# TECHNICAL BULLETIN

## Rough Idle/Engine Misfire – New Spark Plug Wires and Routing

**18-43**

MODEL XJS Range (V12) and XJ12      DATE 11/94

ILLUSTRATION 1

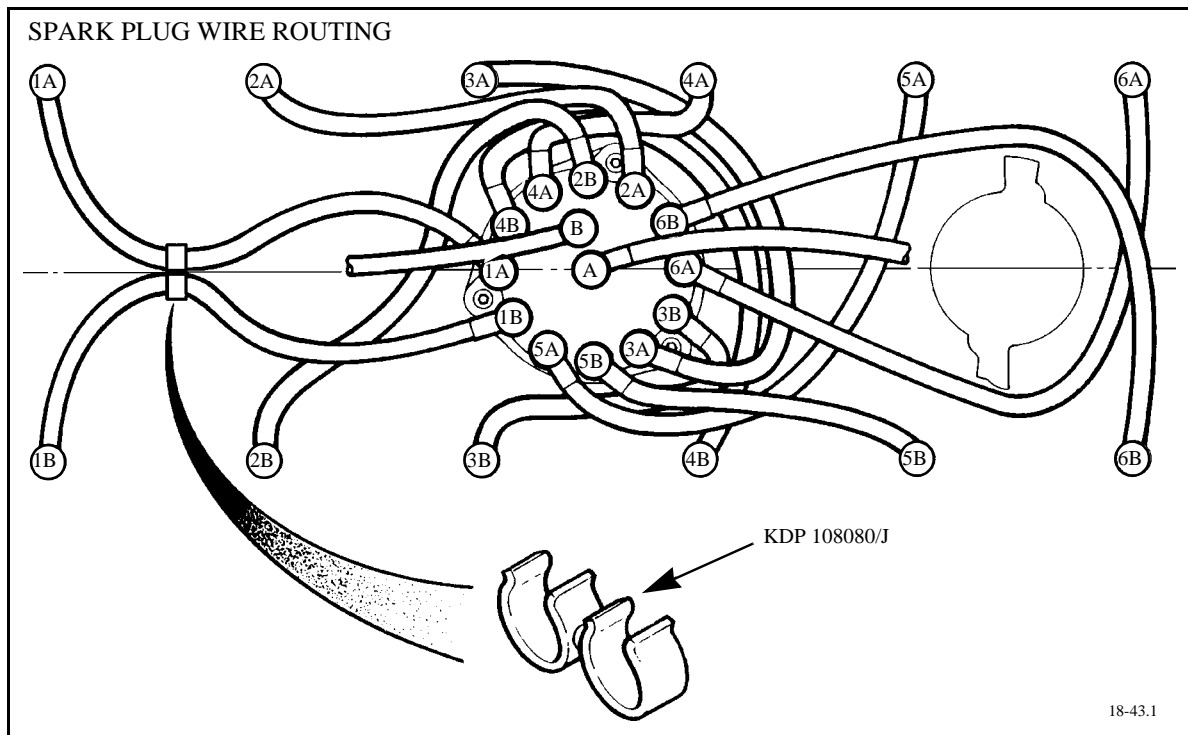
Rough idle and engine misfire conditions that develop after approximately 20,000 miles may be caused by high voltage leaks between the spark plug wires and cylinder head bolts.

New spark plug wire sets with revised routing were introduced in production from the following VIN numbers.

If customers complain of engine misfire or rough idle after approximately 20,000 miles on V12 vehicles produced before the VIN numbers shown above, replace the spark plug wires with the latest version.

Route the new wires as shown in Illustration 1.

**IMPORTANT:** The clip (P/N KDP 108080/J) must be installed on the spark plug wires for cylinders 1A and 1 B as shown in the illustration.
